INNER WEST

DEVELOPMENT ASSESSMENT REPORT

Application No.	DA/2023/0484
Address	72 Short Street BIRCHGROVE
Proposal	Alterations and additions to residential development (new third level and roof terrace)
Date of Lodgement	27 June 2023
Applicant	Mr Ante Zizic
Owner	Mrs Natalie A Zizic Mr Ante Zizic
Number of Submissions	Initial: 0
Value of works	\$119,826.00
Reason for determination at Planning Panel	Section 4.6 variation exceeds 10%
Main Issues	FSR Breach Heritage Bulk & Scale
Recommendation	Refusal
Attachment A	Reasons for refusal
Attachment B	Plans of proposed development
Attachment C	Section 4.6 Exception to Development Standards
Attachment D	Statement of Heritage Significance
Attachment E	Draft conditions in the event the application is approved.

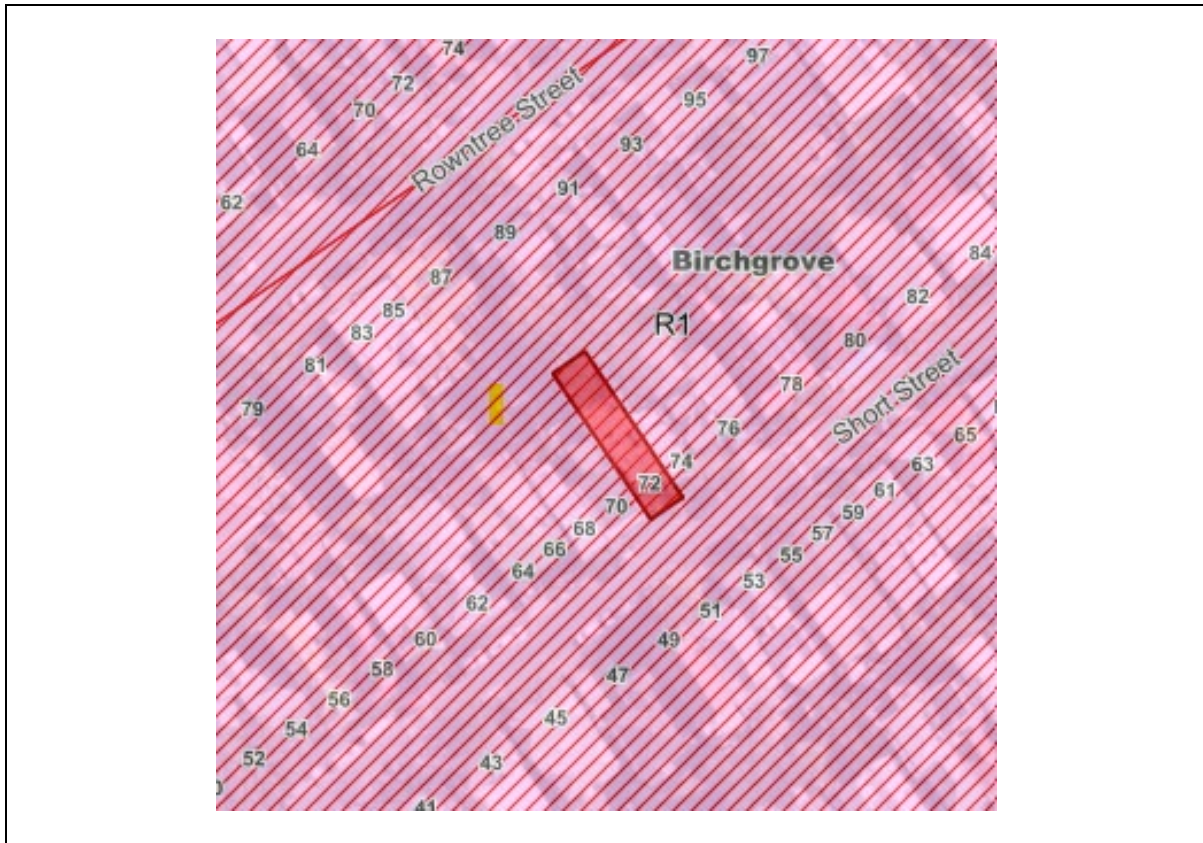
Council contacted the applicant on 8 August 2023 requesting the application be withdrawn as the proposal for a third level and roof terrace could not be supported on heritage grounds and was inconsistent with relevant objectives and controls under the Inner West Local Environmental Plan 2022 and Leichhardt Development Control Plan 2013. The applicant did not respond. Council contacted the applicant in early November 2023 which resulted in the applicant advising that the owners did not want to withdraw the application and requesting that the applicant be changed from the original, Christopher Jordon Architects to the owner of the property.

The proposal is a modified design for a third storey living room and roof terrace in response to partially approved alterations and additions assessed under DA/2020/0872 that conditioned the deletion of a proposed roof top terrace and access stairwell on 26 February 2022.

- Demolition of existing skillion roof form,
- Addition of a third level living room and access stair to the rear portion of the existing skillion roof; and
- Replacement of existing skillion roof with roof terrace.

Roof Plan (DA/2020/0872)

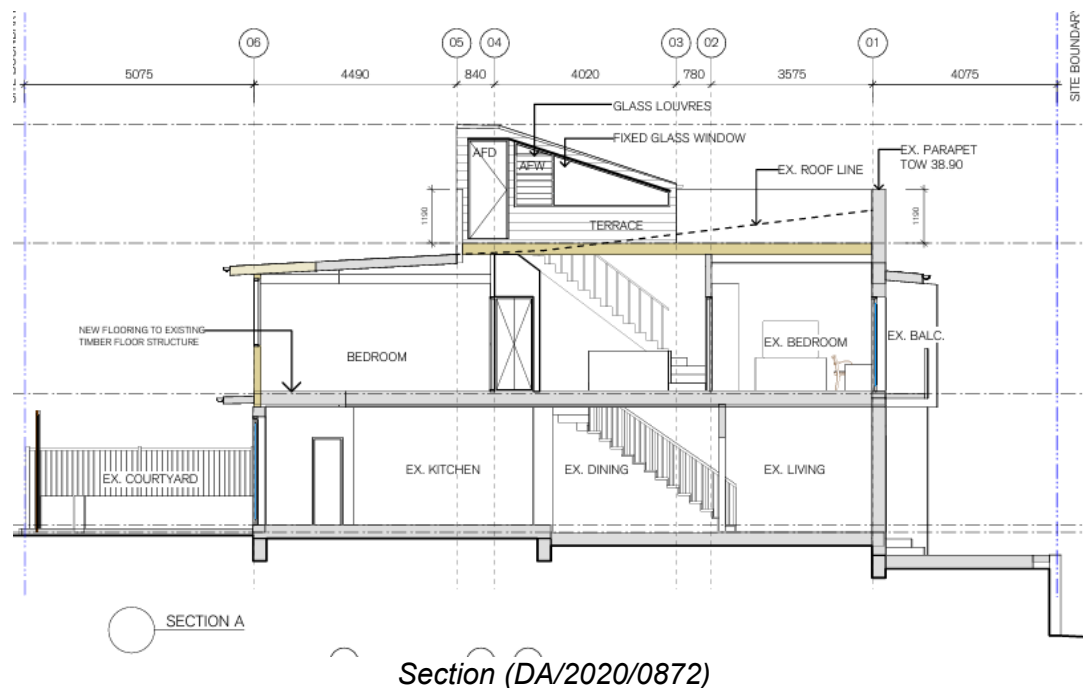
The development application from DA/2020/0872 to infill a first-floor rear balcony approved under D/2005/376 and add an ensuite to the second floor, also sought to demolish part of the skillion roof and add an access stair and roof top deck. This element was not supported by Council and subsequently was conditioned to be deleted.

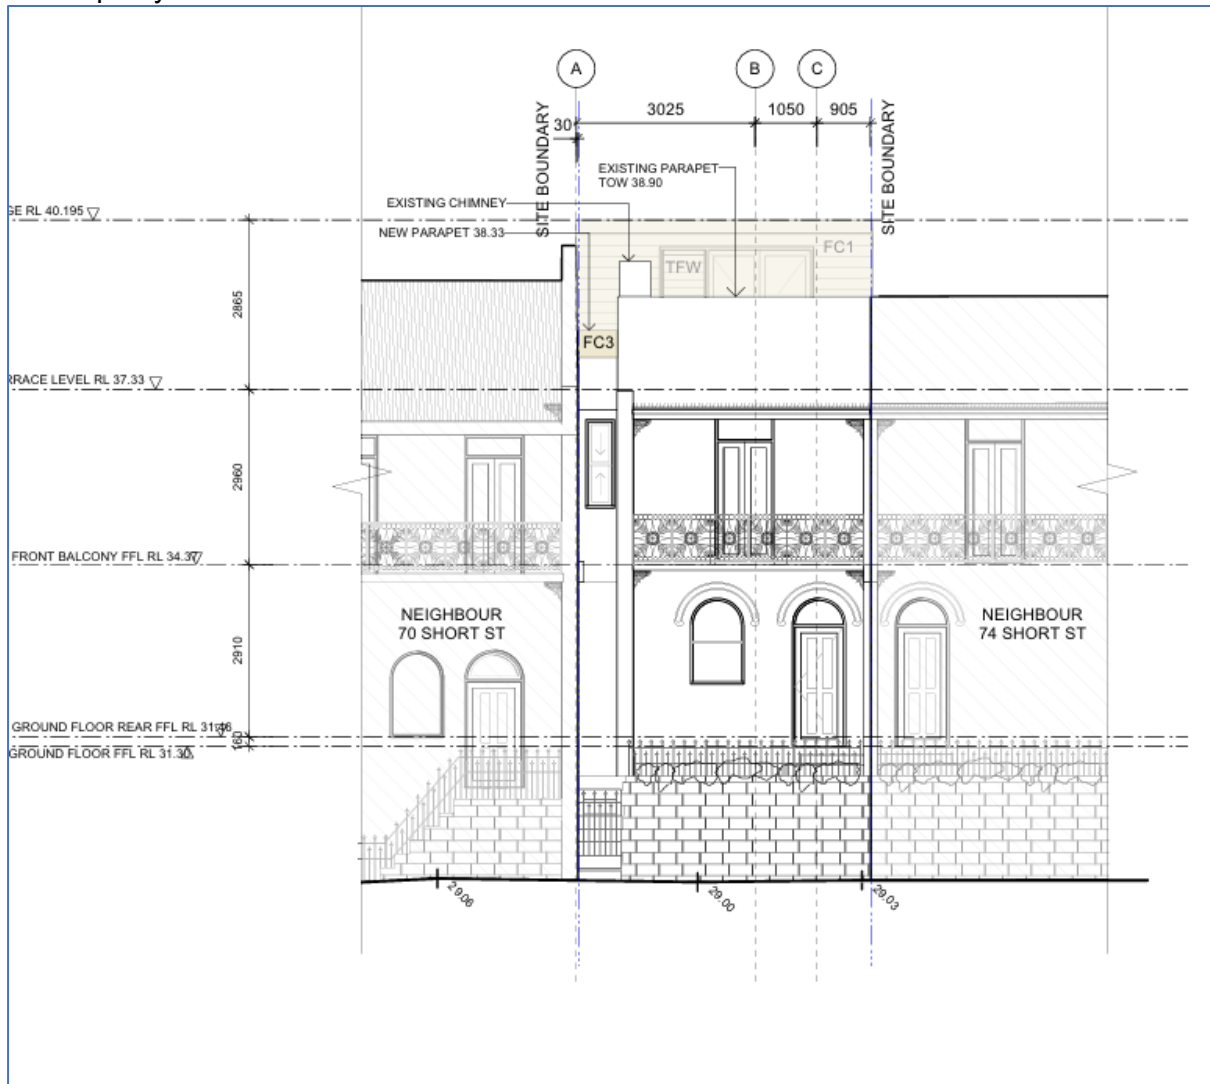
Although a Site Analysis Plan has been provided, the proposal fails to demonstrate compliance with Objective O1 as the proposal is inconsistent with the desired future character of the distinctive neighbourhood and heritage conservation area.

It is considered that the proposed demolition of the skillion roof and replacement with a third storey and roof deck does not meet the objectives and the relevant controls of the clause.
